CASS COUNTY SOLAR & BESS DUE DILIGENCE

Cass County

September 9th, 2024

The objective of 1898 & Co.'s document review was to identify abnormalities in the CUP application and verify that local ordinances are being followed appropriately.

EXHIBIT B - SITE PLAN

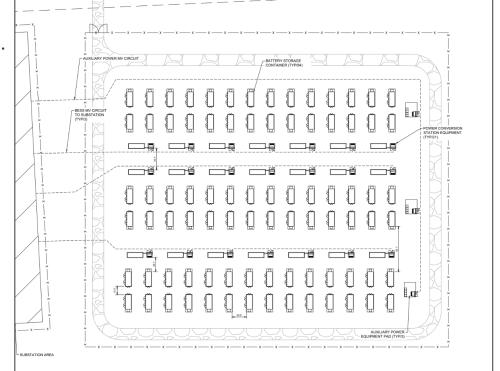
Data		BMcD Commentary
Total Parcel Area (ac)		1,9	961	
Utilized Land (ac)		1,1	114	• A GCR of 38.0% is higher than what is typical in the industry, 30.0% to
Nameplate	e Capacity	Solar: 205.6 MW _{AC}	BESS: 88.2 MW _{AC}	34.0% is more common. Although this results in increased shading effects leading to reduced annual energy production, this does not affect the
Acres / MV	V _{AC}	1,961ac / 205.6MW _A	_C = 8.81 acres/MW _{AC}	county or impede the applicant's ability to comply with ordinance requirements.
Solar Equipment			r BYDxxxMLTK-36* cs FREESUN HEMK FSxxxxK*	 A module bin class and inverter MVA rating are not provided. It is unclear how values for DC and AC capacity are being determined at the time of this report.
BESS Equip	oment	•	ATL 10P416S REEMAQ MULTI PCSM FP4200M4	 A school is located SW of the intersection at Highway 1 and 42nd Street. Modules are planned to be installed within 350' of this school, which

GCR	DC/AC	38.0%	1.35	would violate the 500' residence setback.Wetland disturbances during construction are very likely due to the
Setbacks		Setbacks appear to generally be employed in line with typical industry standards and with Cass County ordinance requirements.		 presence of streams throughout the site. Laydown yards and stormwater retention ponds are not shown in the provided site plan.
Ordinances		Vegetative buffers appear to be emplo require	yed in line with Cass County ordinance	provided site plan.

EXHIBIT J - SINGLE LINE DIAGRAMS

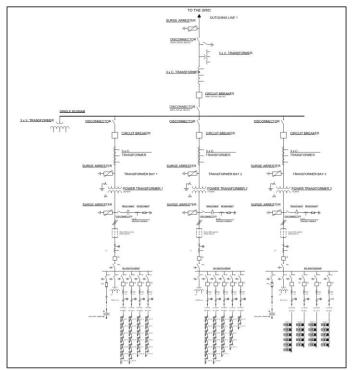
Data	BMcD Commentary
Calculated Capacity	Solar: 222.6 MVA BESS: 88.2 MVA @ 4 hours	
Voltage Levels	35.0kV: 354.0kV	
Arrangement	Two (2) main power transformers (MPT's) for solar, one (1) MPT for BESS. No main-tie switch between the solar switchgears will prevent redundancy.	 Many necessary ratings for equipment are absent from the single line diagram.
Equipment	Transformers, inverters, bus bars, and switches are present where expected. Revenue meter(s) are absent, grounding transformers are absent though these may not be necessary.	 Several of the ratings present in the single line diagram are inaccurate or entirely incorrect, including the MVA rating for MPT 1 and the grid voltage. This diagram does not appear to be an accurate representation of the
Ratings	HV rating and MVA rating of MPT's are incorrect. Voltage and current ratings are missing for MPT, bus bars, switches, and most breakers.	project as depicted in the Site Plan.

Protection & Controls	Breakers, voltage transformers (VT's) and current transformers (CT's) are present where expected. Relays are excluded from the current SLD.
